REGULATORY INFORMATION DISTRIBUTION SYSTEM (RIDS)

SUBJECT: Forwards responses to 781103 First Round containment sys branch questions. Responses will be formally submitted as amend to FSAR.

Docket No. 50-397

Subject: WPPSS NUCLEAR PROJECT NO. 2
RESPONSES TO FIRST ROUND
CONTAINMENT SYSTEMS BRANCH QUESTIONS

FIGURE 2-1. VALVE CROSS SECTION
(DUAL DISC)

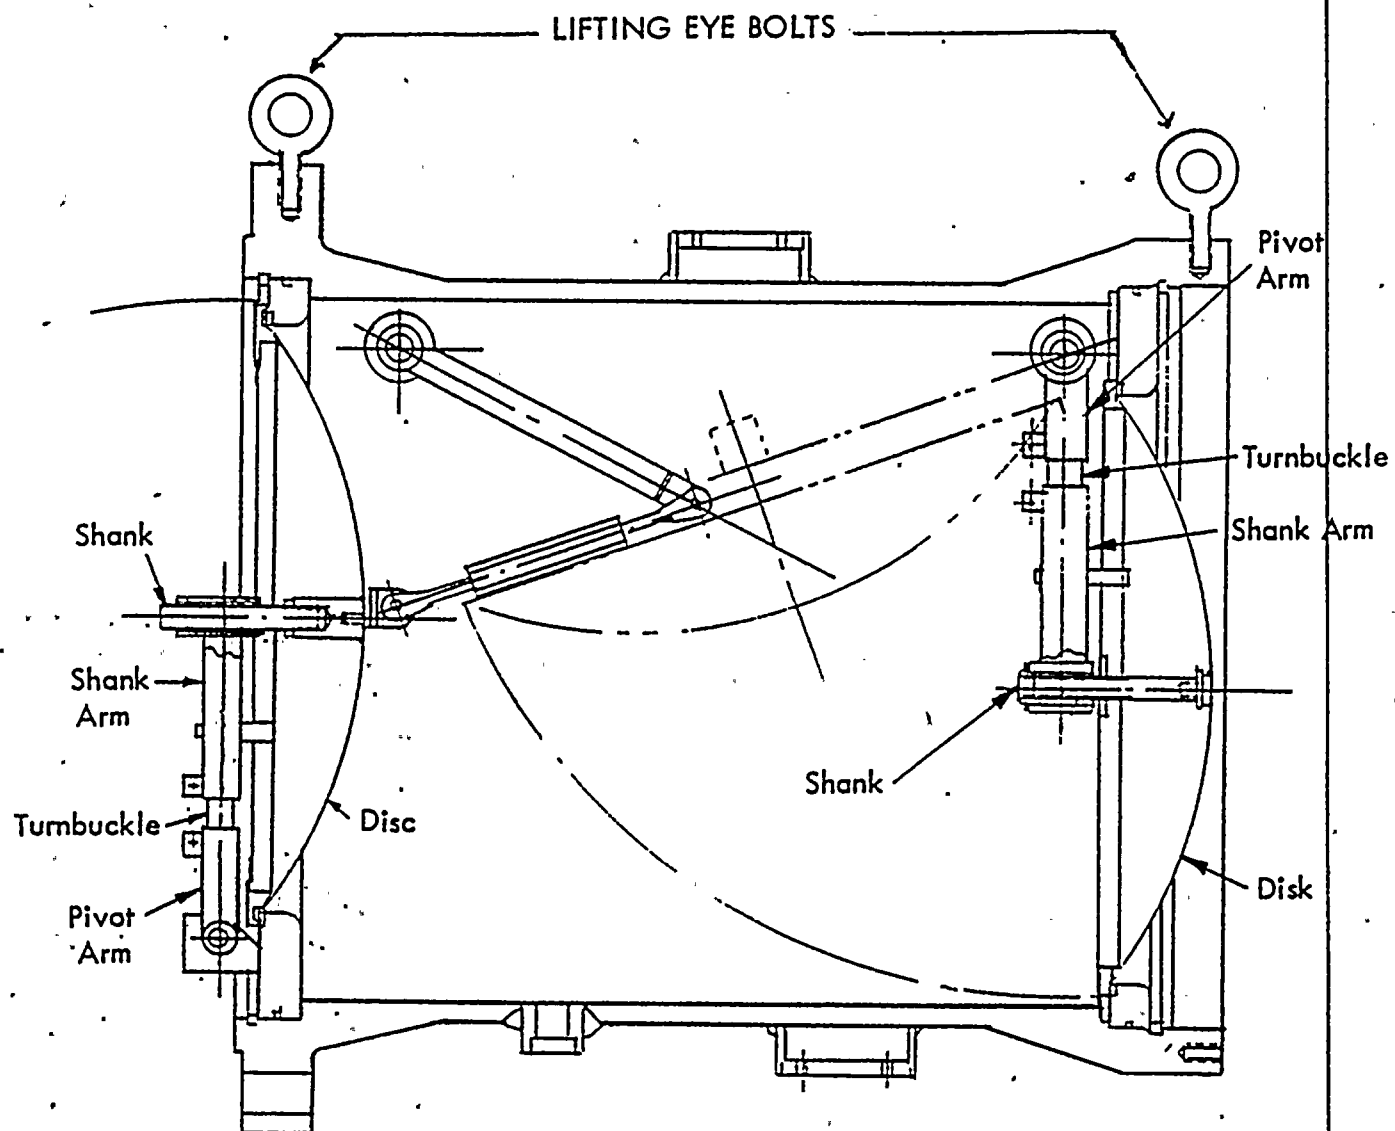
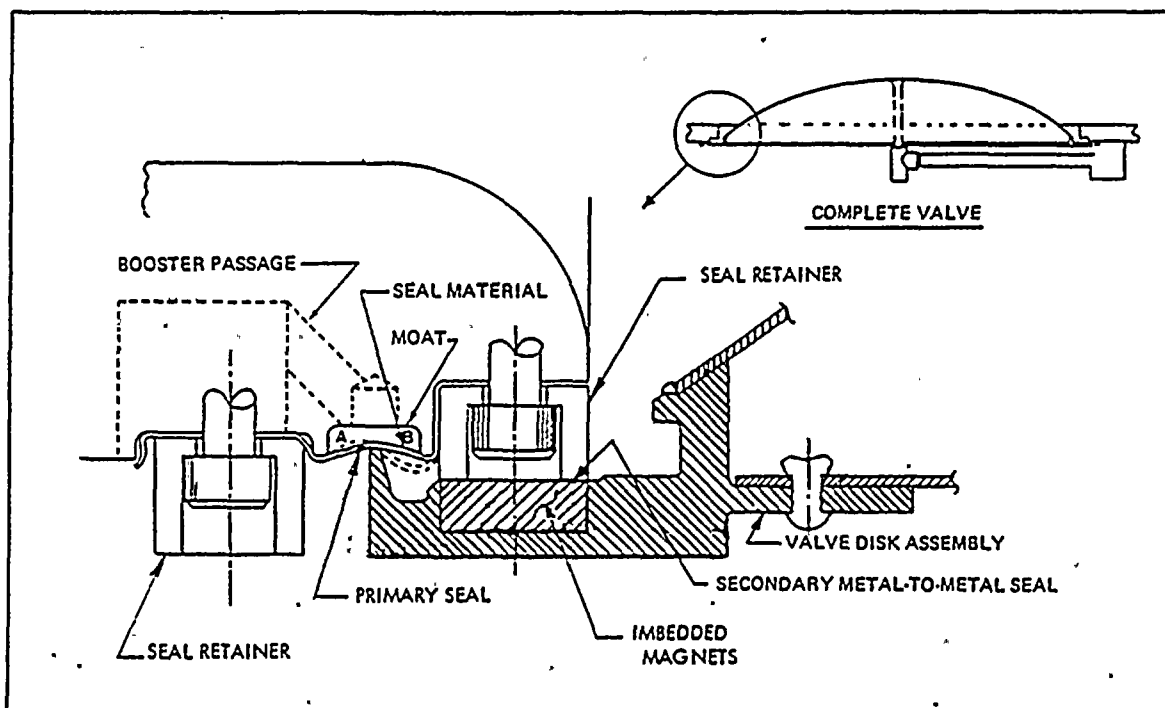
- c. Provide a schematic of the vacuum breaker assembly. Provide your analysis of the minimum flow area and the total loss coefficient for one vacuum breaker assembly.

RESPONSE:

The attached Figures (2-1 and 2-2) from the manufacturer's instruction manual illustrate the configuration of the double disk vacuum breaker assembly, and the seal detail. FSAR Reference 3.8-8, which was provided to the NRC, also provides illustrations and details of the vacuum breaker system and the Anderson, Greenwood & Co. vacuum breaker valves.

The minimum flow area of the vacuum breaker valves is 295.6 square inches based on the 19.4 inch diameter inlet orifice. Capacity certification tests were performed on 3 wetwell-drywell and 3 reactor building-wetwell vacuum breaker valves. Using the flow data from these tests, resistance coefficients (K) were determined as follows:

Wetwell-Drywell valves - 4.73 at 0.360 psid

Reactor Building-Wetwell valves - 1.65 at 0.289 psid

These values of K include valve entrance effects and are based on the connecting piping internal area of 424.6 square inches.
